December 19, 2022

ADDENDUM NUMBER ONE (1)

Project: Tippah County Hospital  
EMS Building  
PN: 22005

FROM: Dean Architecture, P.A.  
661 Sunnybrook Road, Suite 140  
Ridgeland, MS 39157  
(601) 939-7717

**C3.1**

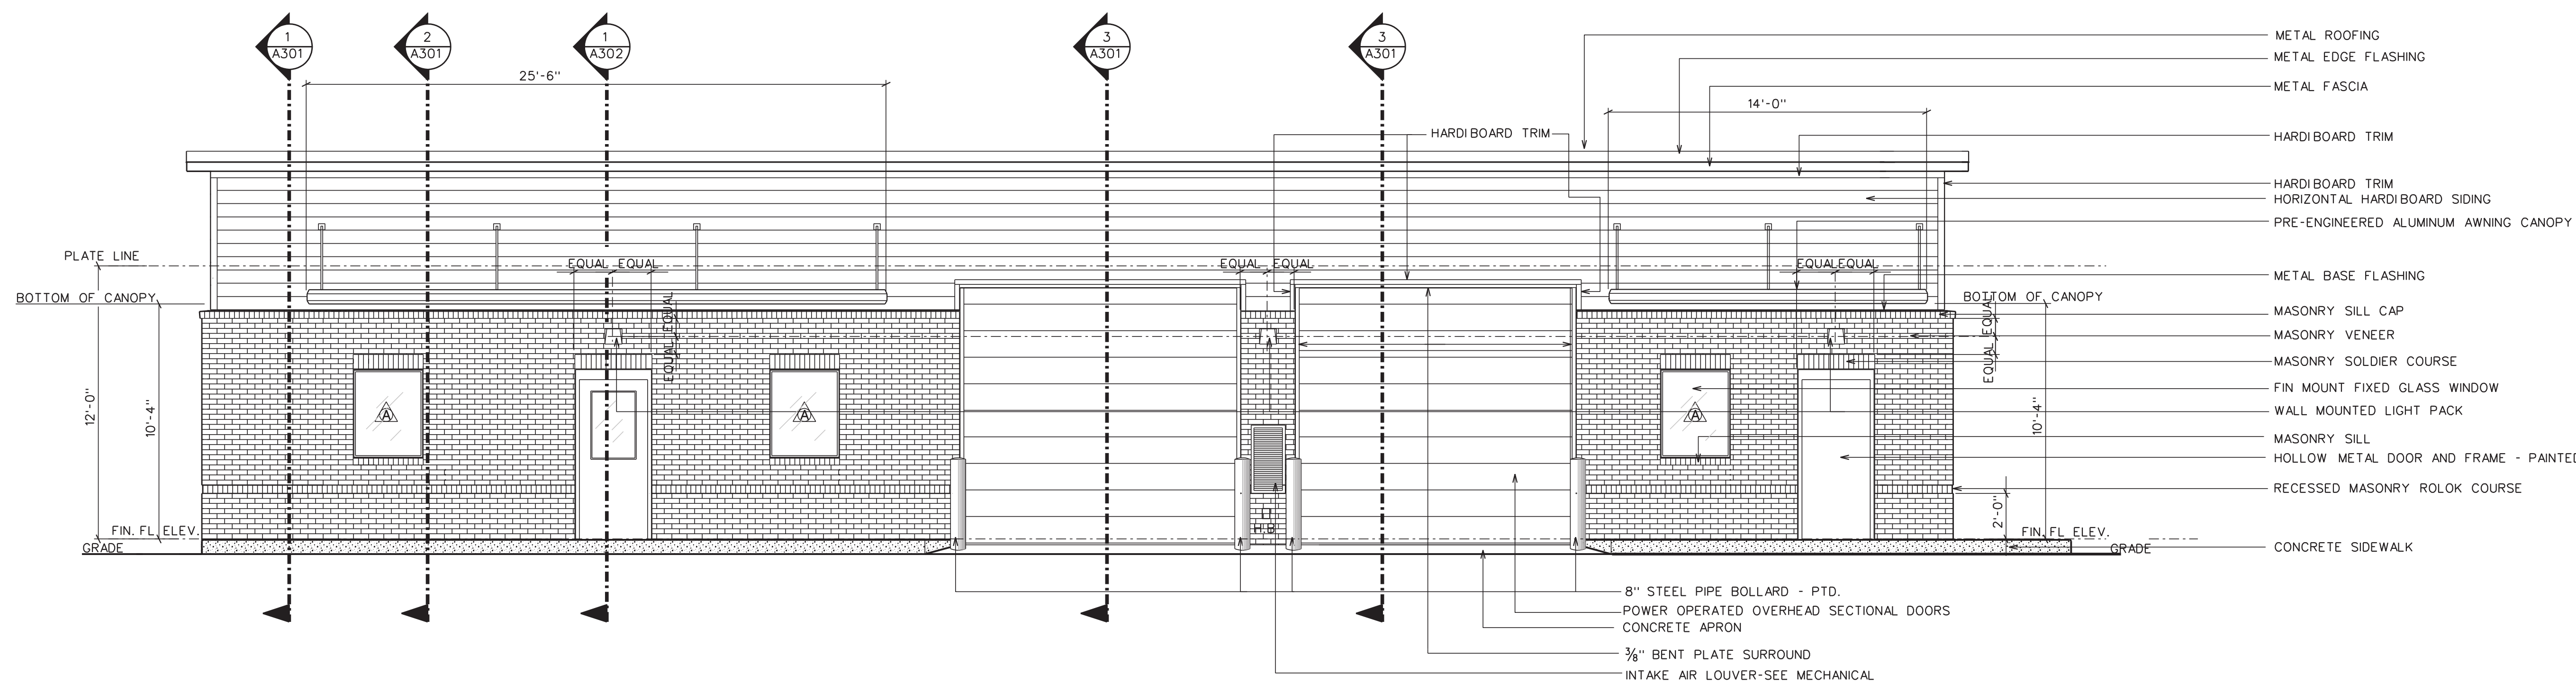
- Item 1. The size of the fire line shall match F-100. C3.1 has been revised.
- Item 2. This is to facilitate the construction and function of the concrete flume for drainage. If this can be accomplished by only moving the guy wire, then this is acceptable. It is also acceptable to install a temporary guy wire for support during the installation of the concrete flume that could be removed once construction is complete.

- Item 1. C3.1 has been revised.

1 EXTERIOR ELEVATION  
A201A SCALE : 1/4" = 1'-0"

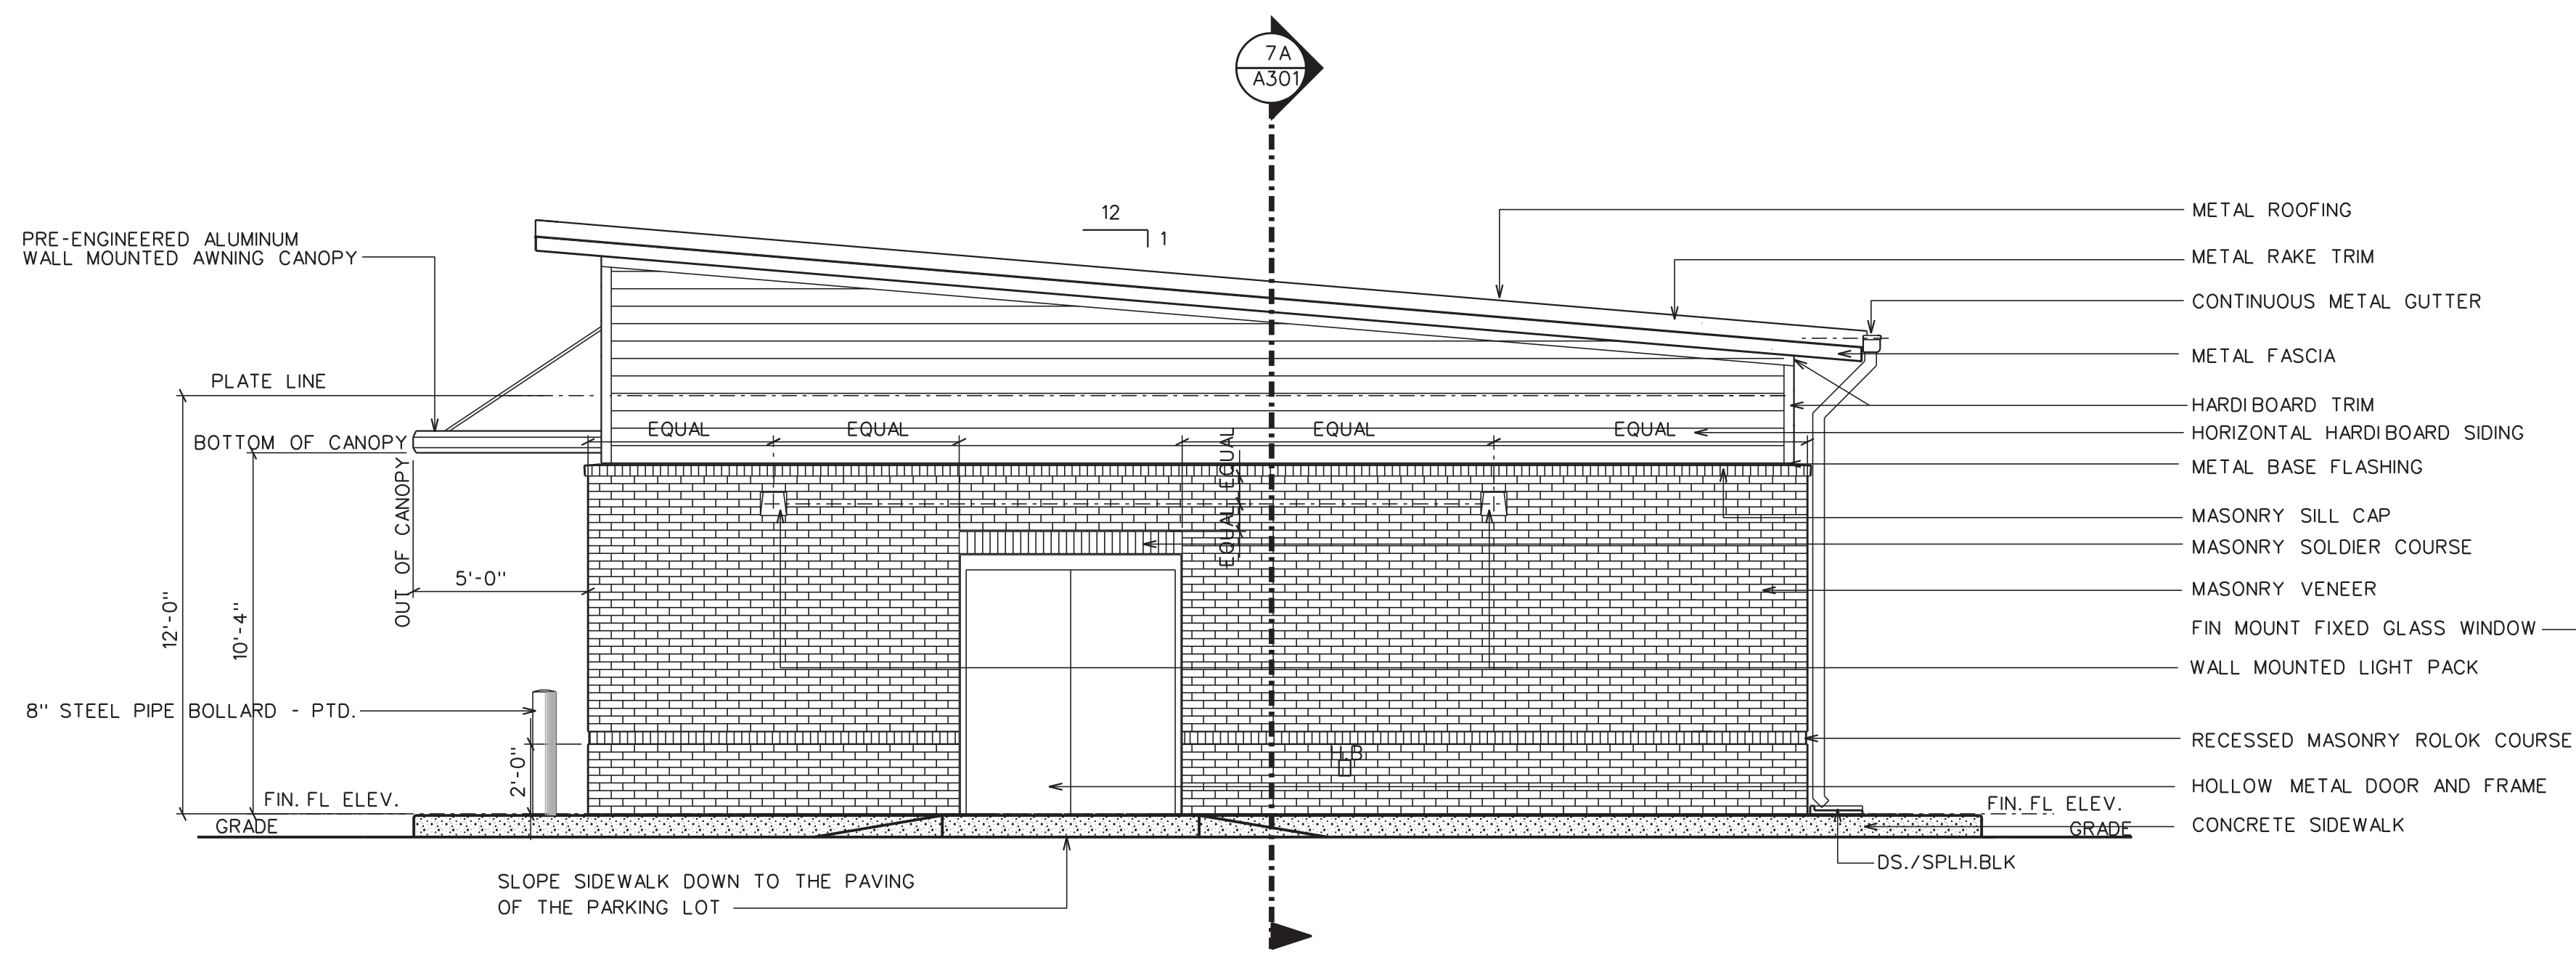
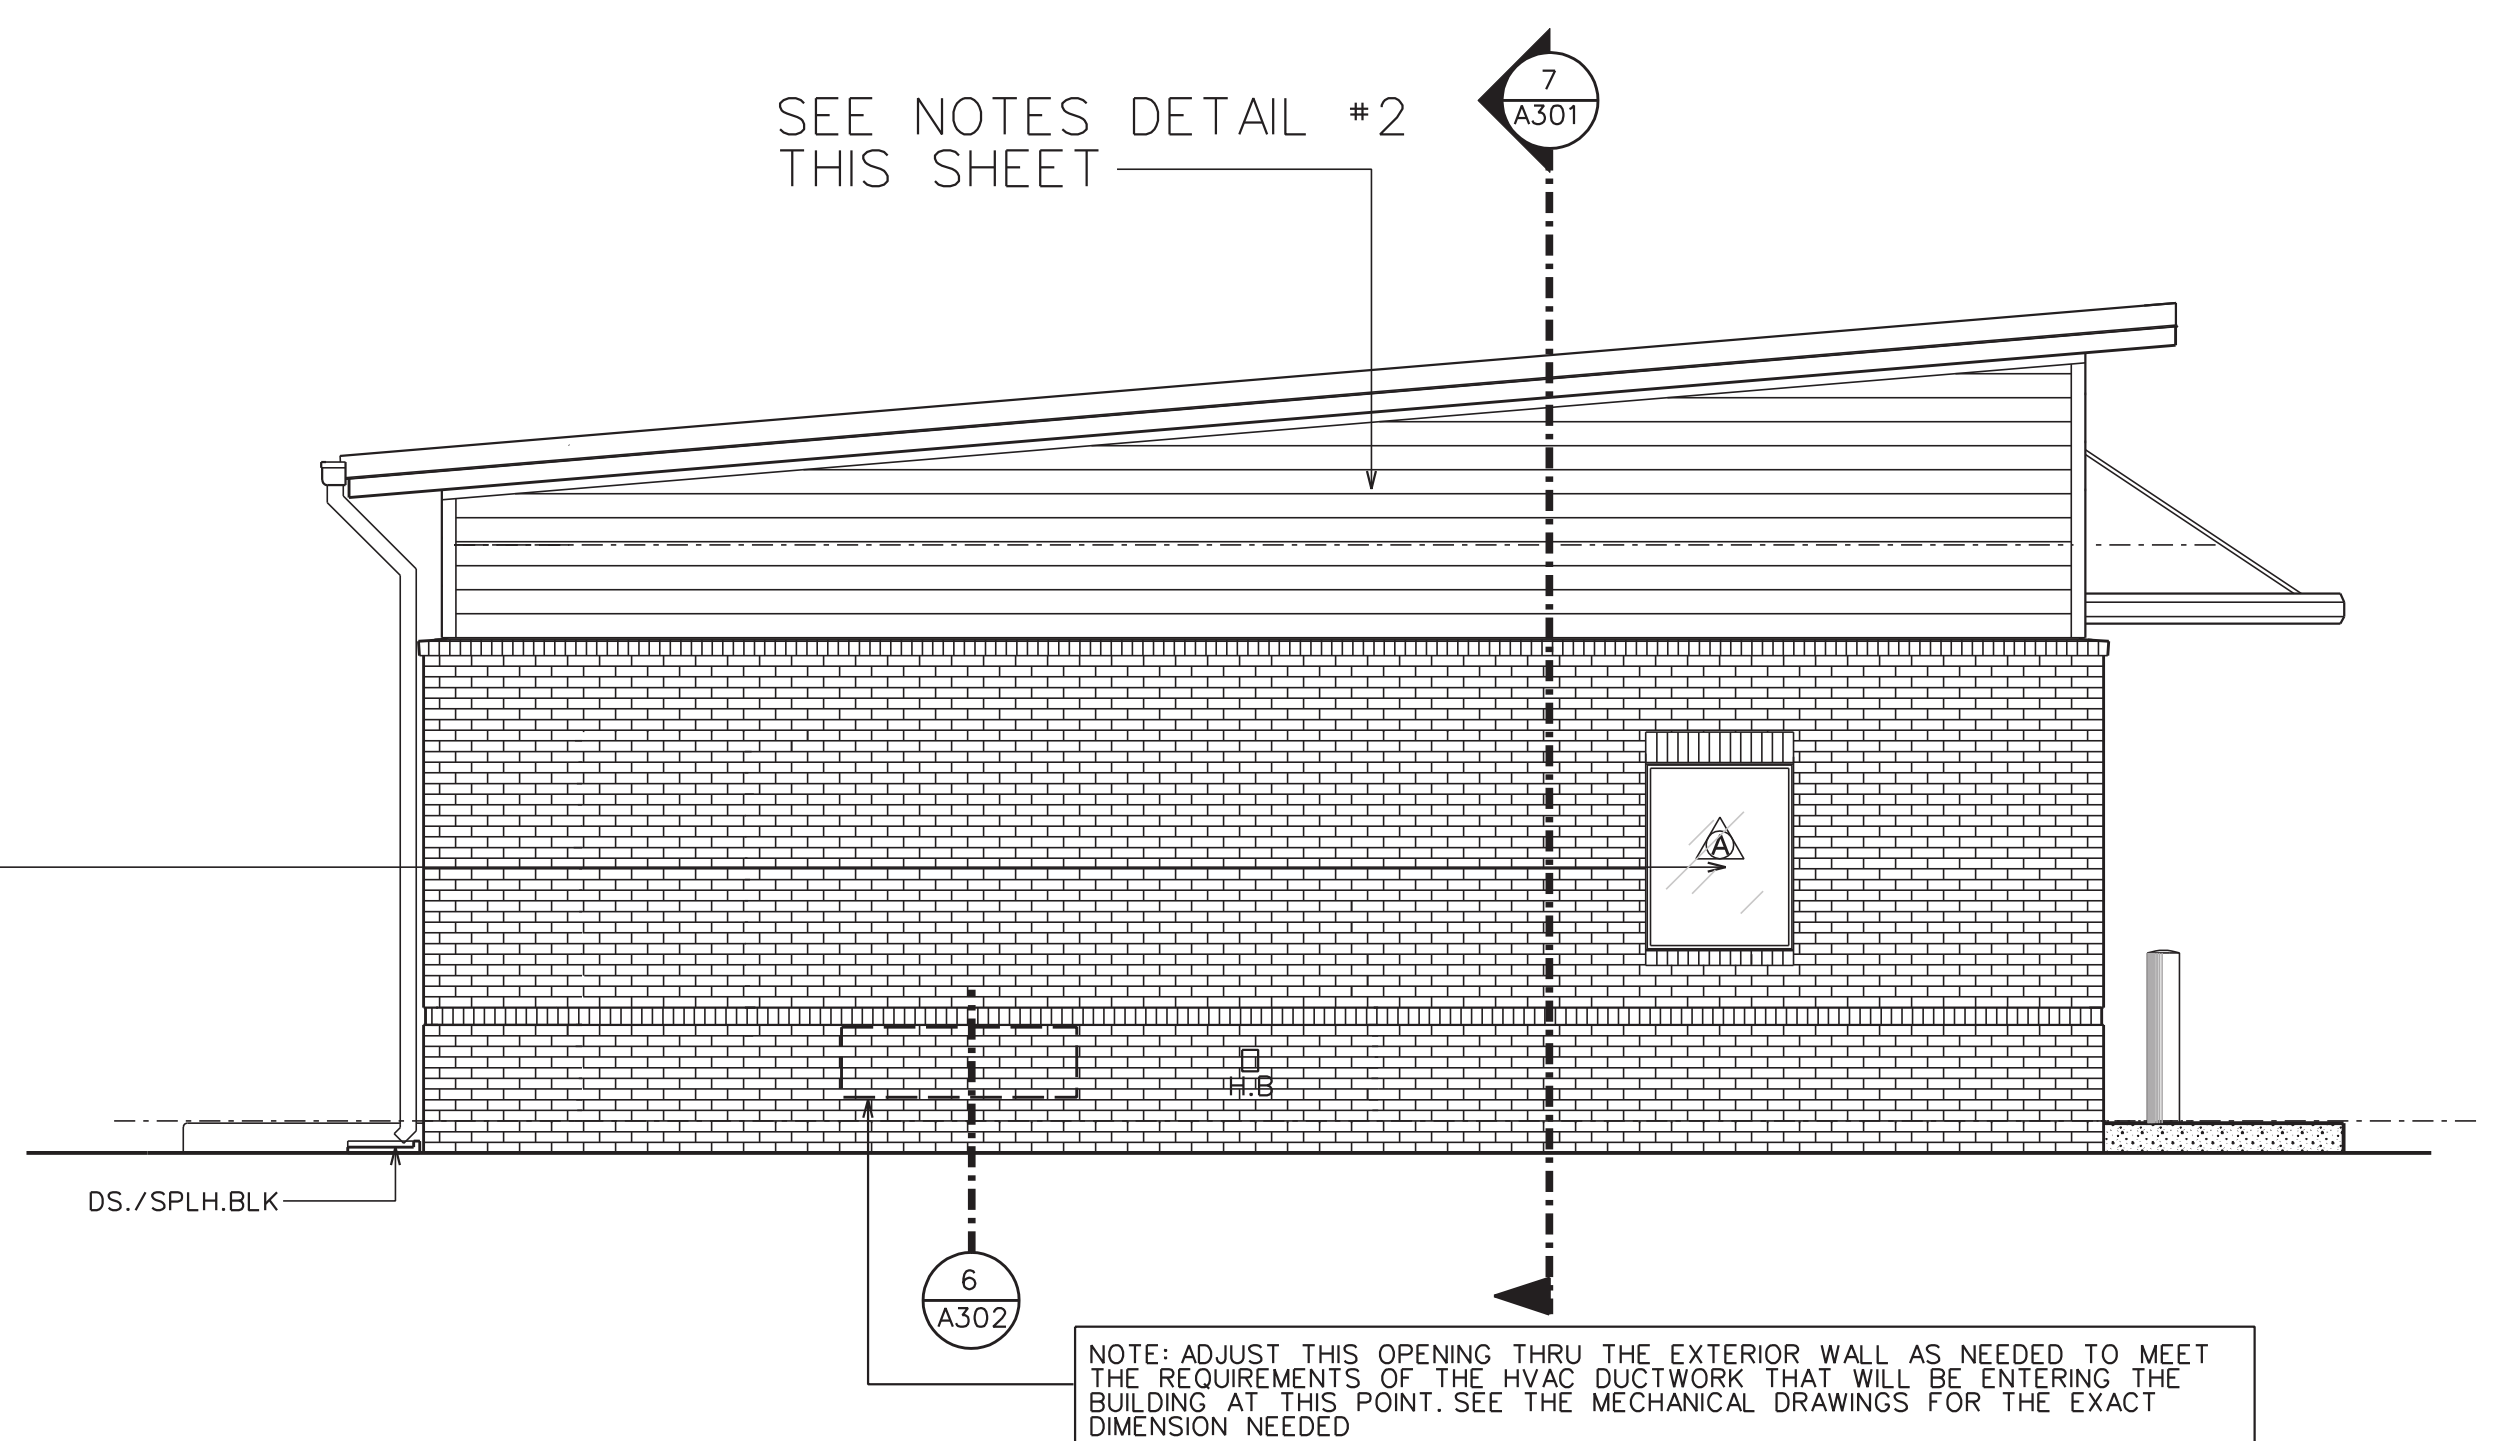
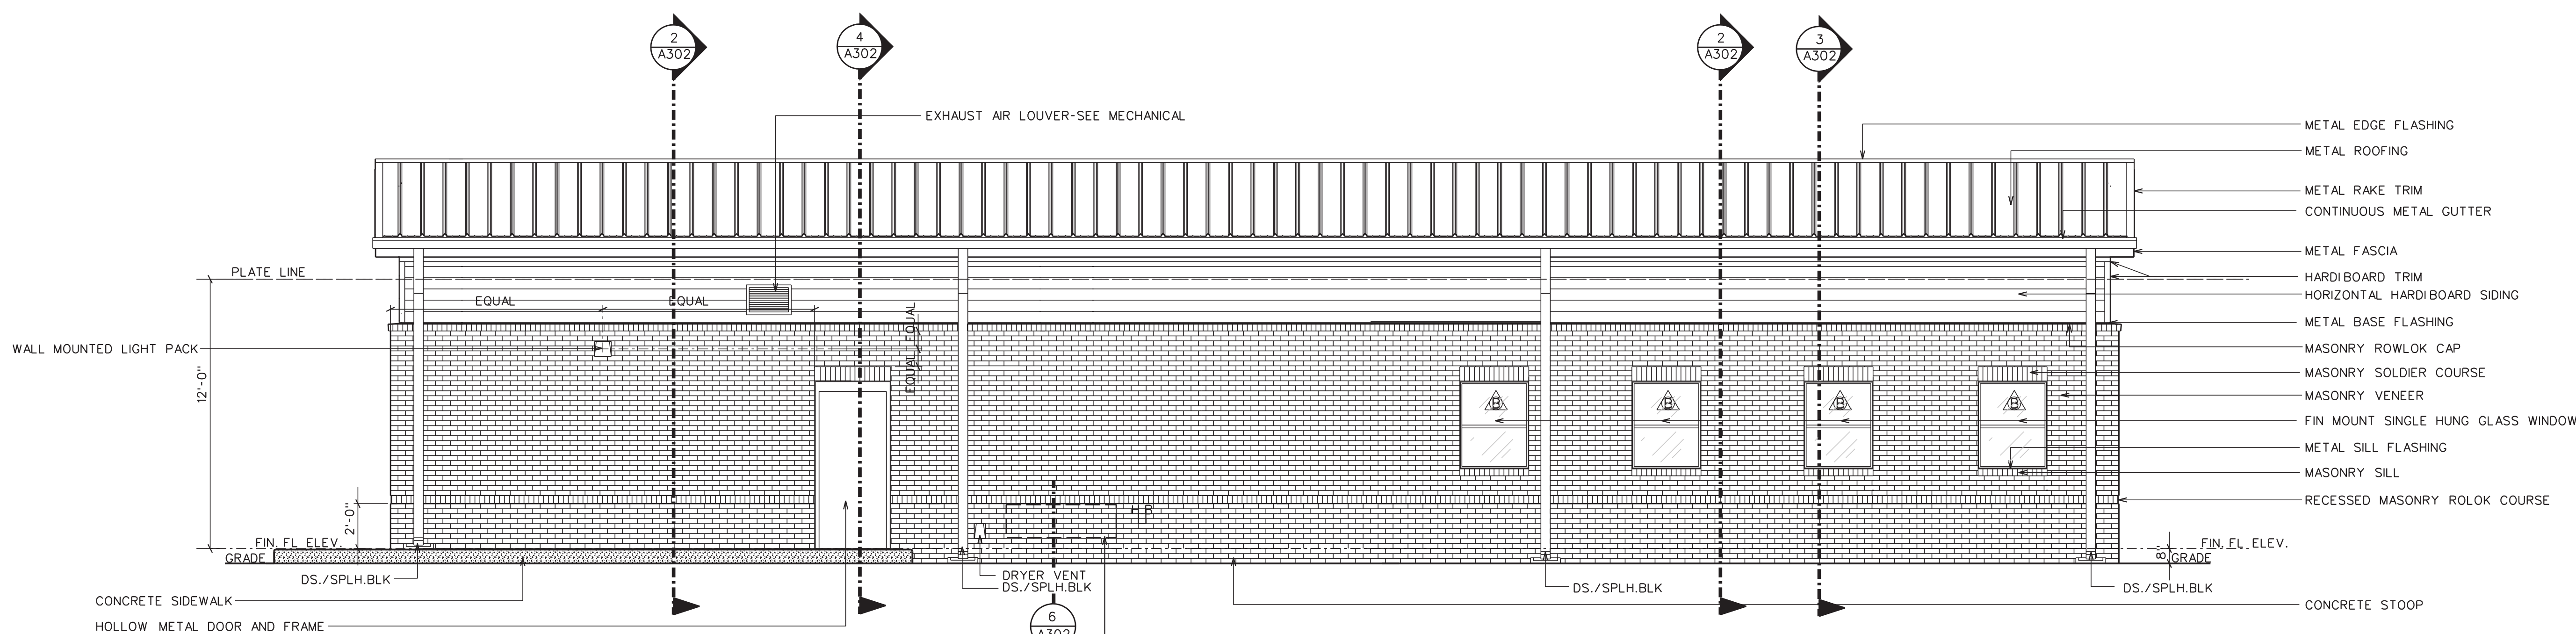
- Item #1:** Add sheet A201-A, Alternate Building Elevation dated Dec 19, 2022 to the bid documents.
- Item #2:** Sheet A901 – remove reference to plastic laminate cabinet finishes and change to painted birch cabinets per specifications section 064100. See revised Sheet A901 attached.

- A. Alternate No. 1 - Hardiboard Siding - Provide deductive price to furnish and install painted Hardiboard siding in lieu of prefinished metal siding as shown on the drawings. ( Sheet A201A)
- B. Add Alternate No. 2 - Provide price to furnish and install the Emergency Generator including all associated accessories required per the Electrical Drawings.
